SUBJECT: **Addendum #3 – I-15 La Mesa Nisqualli Interchange Project, San Bernardino County, in the City of Victorville, California, and SANBAG Contract No. C12010**

Addendum No. 3 is hereby issued to the following documents for I-15 La Mesa Nisqualli Interchange project in San Bernardino County, in the City of Victorville, California.

Dist	COUNTY	ROUTE	KILOMETER POST TOTAL PROJECT	SHEET No.	TOTAL SHEETS
08	SBD	15	61.5 / 63.4	213A	376

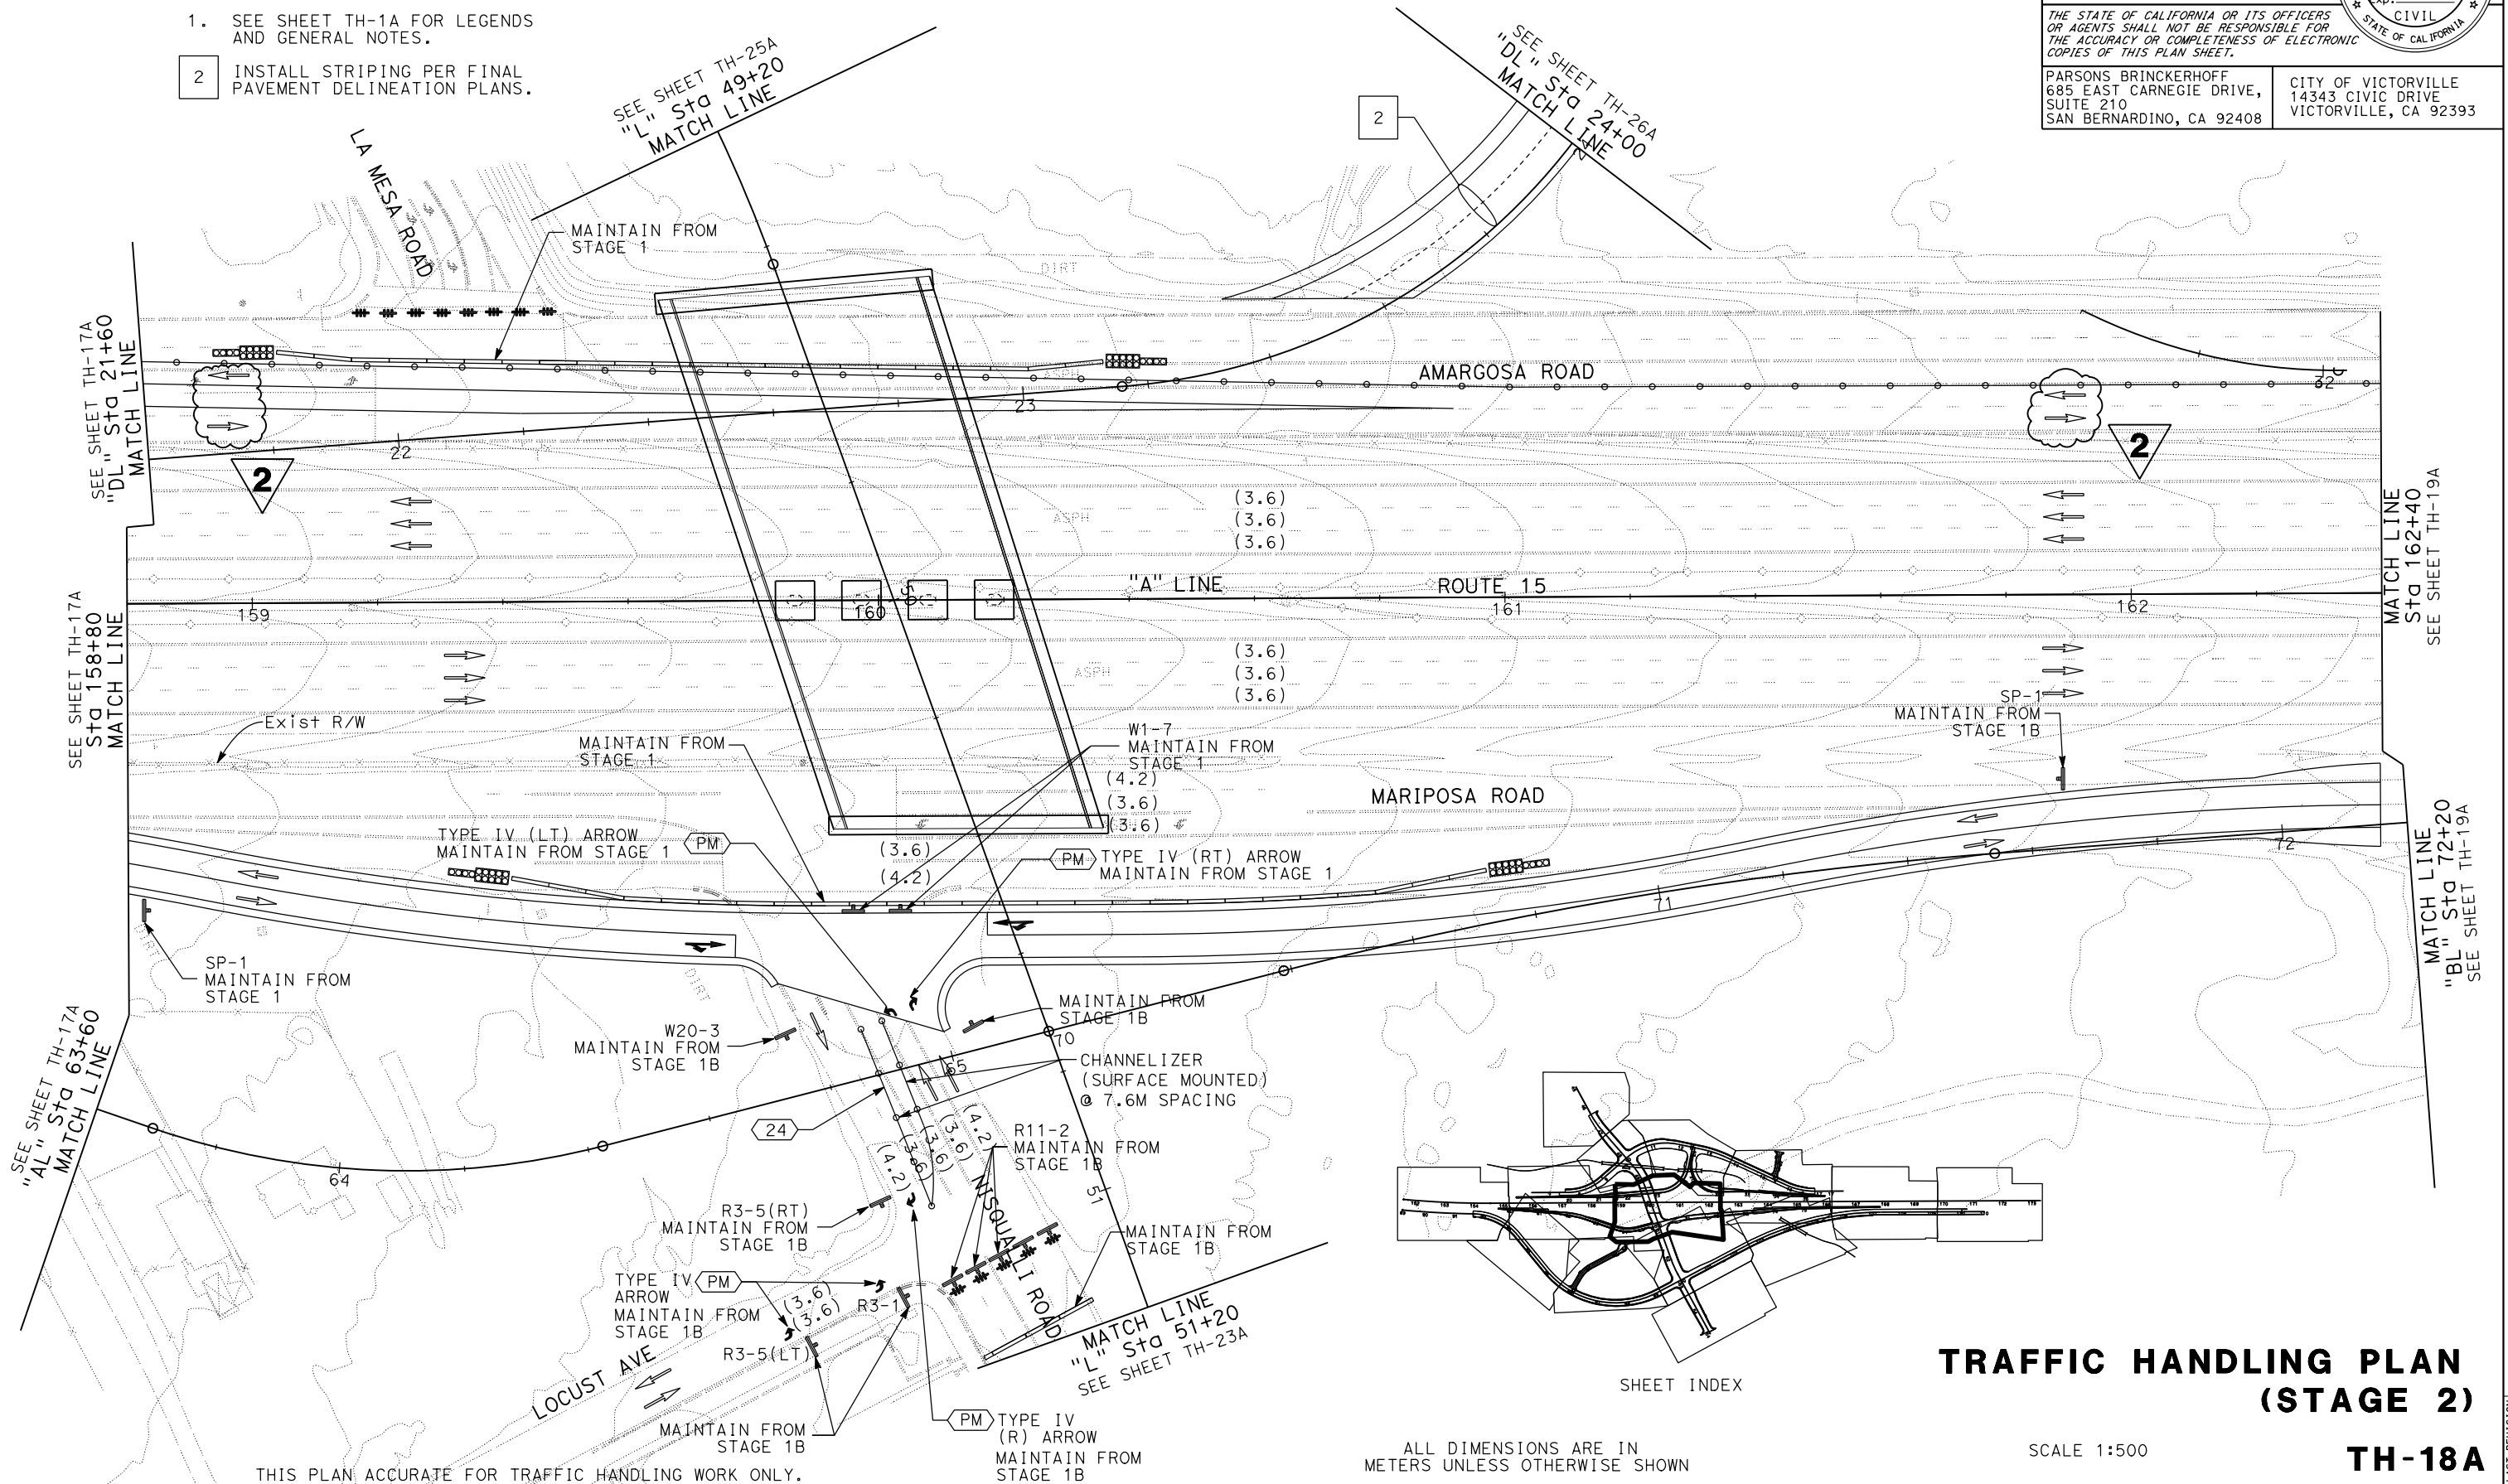
- 1. In Plan Set A, on Sheet U-5 (175 of 376) the note pertaining to the transverse FO crossing near Station "A" 169+23 should reference "E" rather than "C" (Relocation by others).**
- 2. In Plan Set A, on Sheet U-12 (182 of 376) the note near the top of the sheet pertaining to "FIBER OPTIC (VERIZON) 8-102 mm CONDUIT" should reference "E" rather than "C" (Relocation by others).**
- 3. In Plan Set A, replace sheet TH-18A (213A of 376) with the attached sheet 213A -Addendum #3.**

DIST.	COUNTY	ROUTE	KILOMETER-POST TOTAL PROJECT	SHEET NO.	TOTAL SHEETS
08	084	15	61.5 / 63.4	315A	376

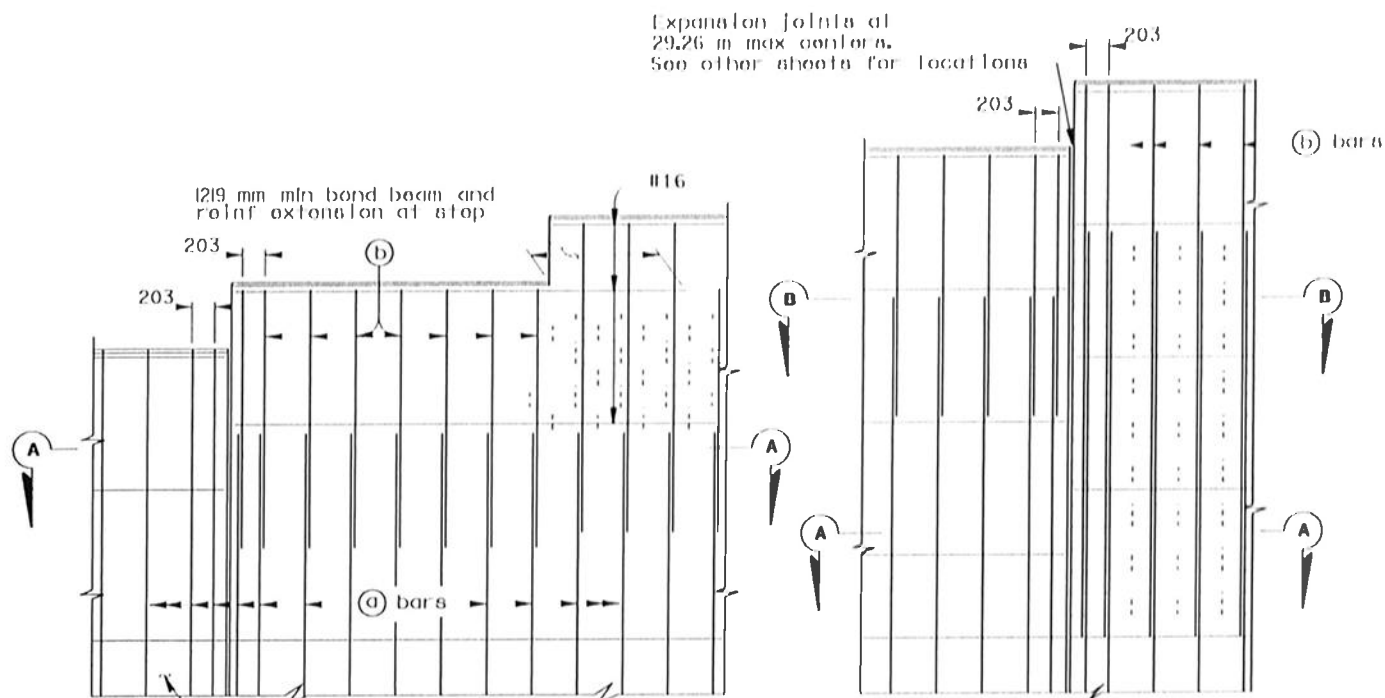
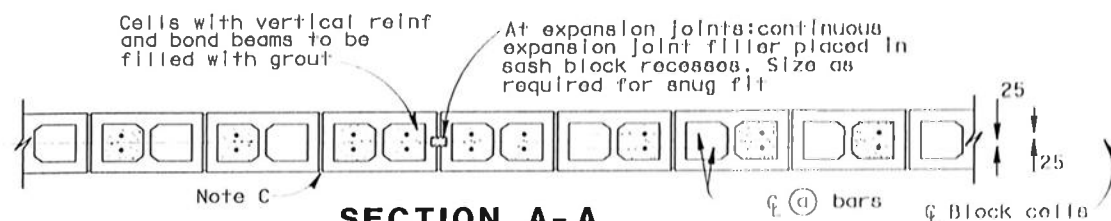
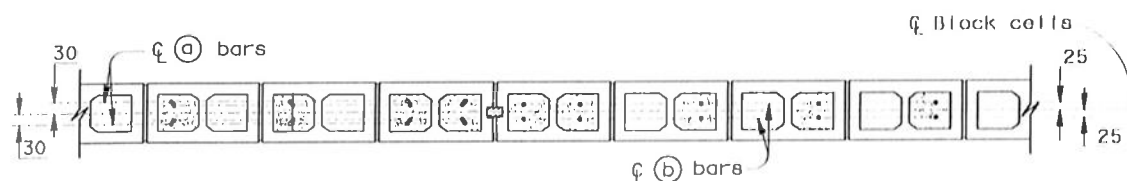
5. In Plan Set A, add sheets SW-16A and SW-16B (315A and 315B of 376) as attached sheets 315A and 315B Addendum #3.

33. Question: On sheets 300 thru 315 of the project plans, the sound wall profiles and details are shown. Sound walls "NB 6-3" & "NB 6-5" both have portions of CMU sound wall that are built on top retaining walls. Usually there is a CMU design reinforcement table or structure detailed sheet for CMU walls on retaining walls that show whether or not high stress units are required for these walls. Usually this sheet is toward the end of the sound walls plans, where it details whether the entire wall requires high stress or only certain portions, (min height) are to be built with high stress CMU. There are no sheets in this section. Furthermore, if you were to reference CT 2004 std plans and plates, you won't find an example of a CMU wall built on a retaining wall. These sheets are specially designed and inserted into the project, on a per project basis. Please clarify or insert a correct design section of the CMU on retaining wall that shows whether or not high stress CMU is required.

Response: Added Plan sheets SW-16A and SW-17B included in this addendum.
